E4990A-02A

Information Only Service Note

E4990A – Impedance Analyzer, 20Hz to 10/20/30/50/120 MHz

E4990A Chassis Assembly and Rear Panel replacement part number change.

Figure 1- 1 New Rear Panel and Chassis Assembly

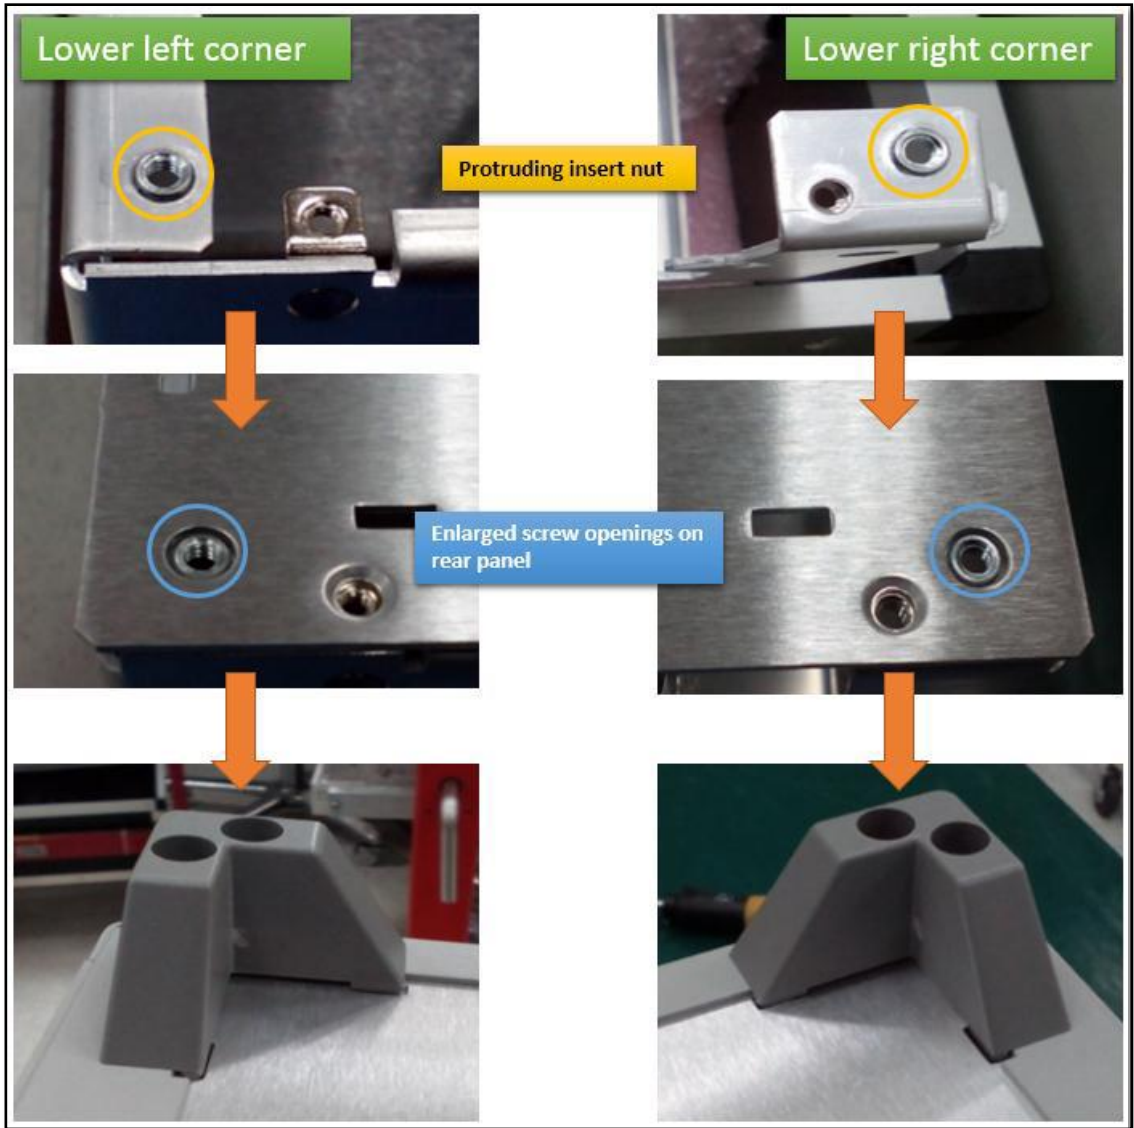
New and improved rear panel and chassis assembly is introduced. Due to mechanical (dimension) change, both rear panel and chassis assembly are required to be replaced with “new” part number on hardware compatibility when either one of the “old” part number is depleted.

The new and improved rear panel and chassis assembly would to further improve the grip between the rear panel and chassis assembly. The insert nut of the chassis assembly is made to be slightly protruded (~1.2mm) resulting in the direct contact (same surface) when the rear panel (~1.2mm in thickness) is installed.

Replace **both** rear panel and chassis assembly whenever one of the following old part is required to be replaced. Shown in Table 1-1 is the replacement part support plan for E4990A. Refer to Figure 1-1 for the detailed illustration on the changes.

Perform full calibration in ensuring the instrument is well within specification since the chassis assembly replacement would require the removal and assembly of analog modules.
